DOCKET	
09-AAER-2	
DATE	MAY 31 2011
RECD.	MAY 03 2011

2010 Rulemaking Proceeding Phase II on Appliance Efficiency Regulations

Comment of APC by Schneider Electric

Diagram 1
Standby Topology UPS

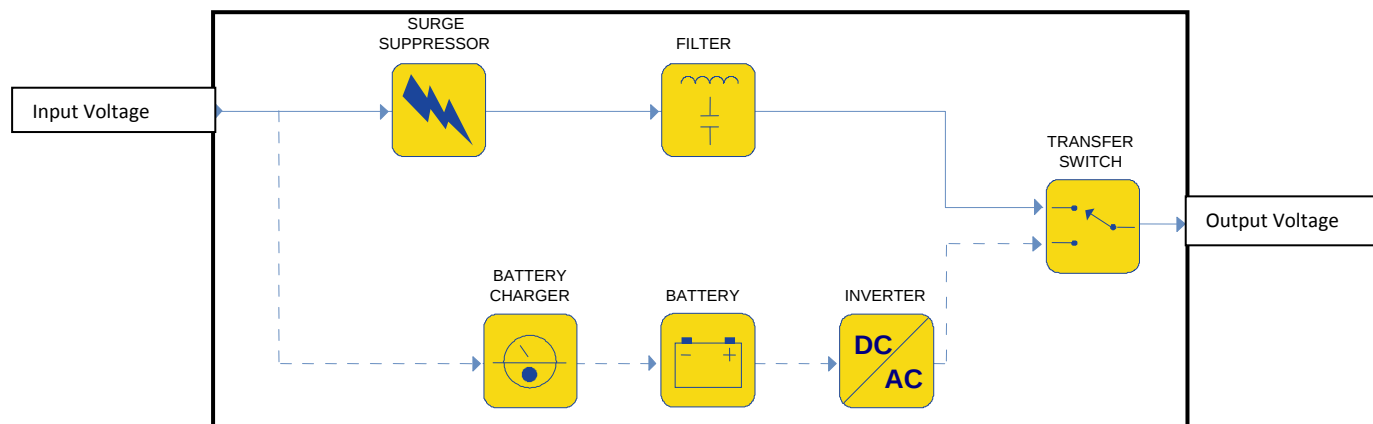
As you can see from the diagram, the battery charger and battery circuitry is not in the direct path of power. However, other component such as filters and surge suppressors are. What this means practically is that measuring the battery charger components outside of the influence or control of other components is an unreasonable burden on the design for UPS systems.

Diagram 2
Line Interactive UPS

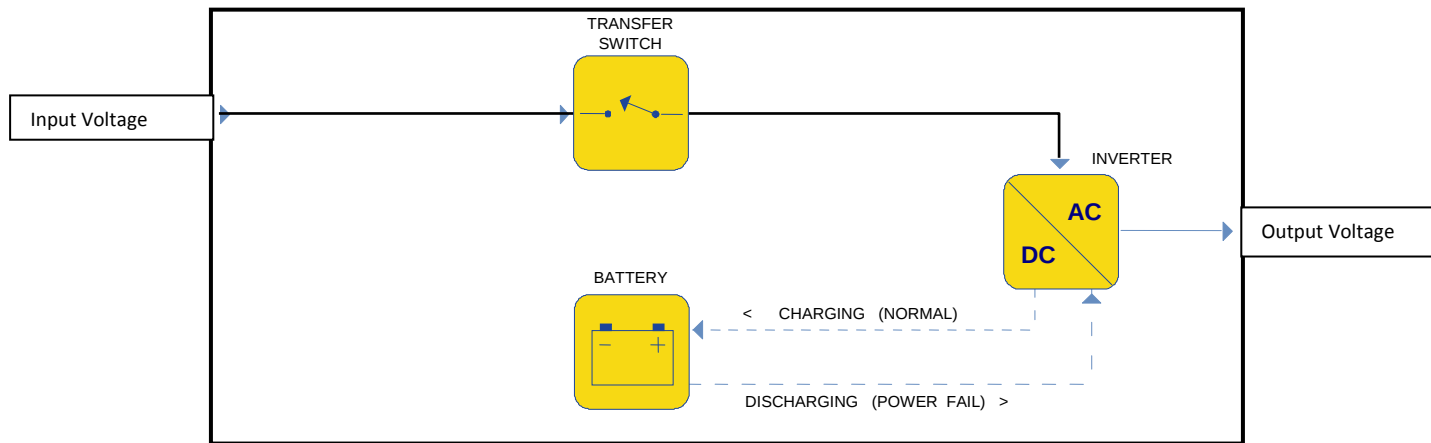
As you can see from the diagram, the battery charger and battery circuitry is not in the direct path of power, as the charger is the inverter circuitry operating with reverse power flow. What this means practically is that measuring the battery charger components outside of the influence or control of other components is not possible.

Diagram 3
Double Conversion

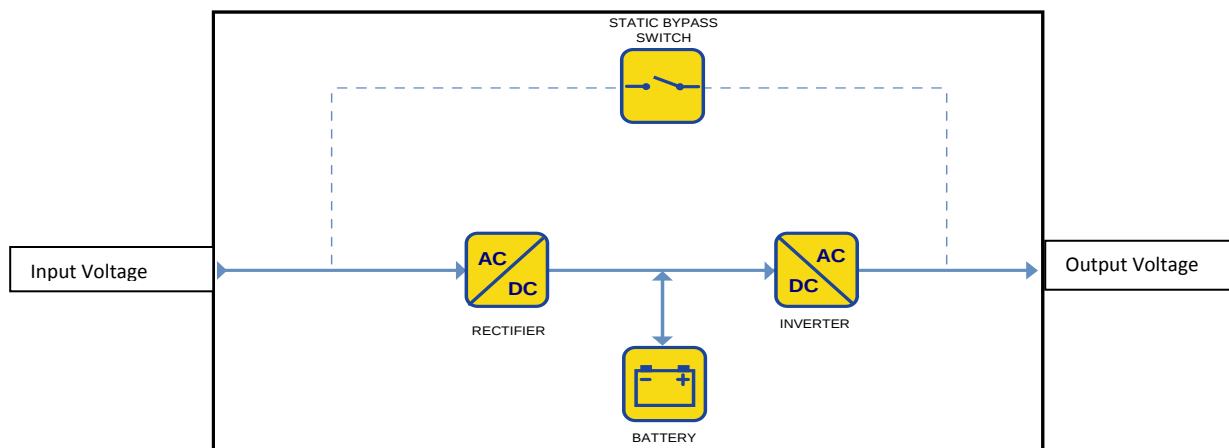
As you can see from the diagram the main rectifier acts as the battery charger. What this means practically is that measuring the battery charger components outside of the influence or control of other components (rectifier/inverter) is an unreasonable burden on the design for UPS systems.
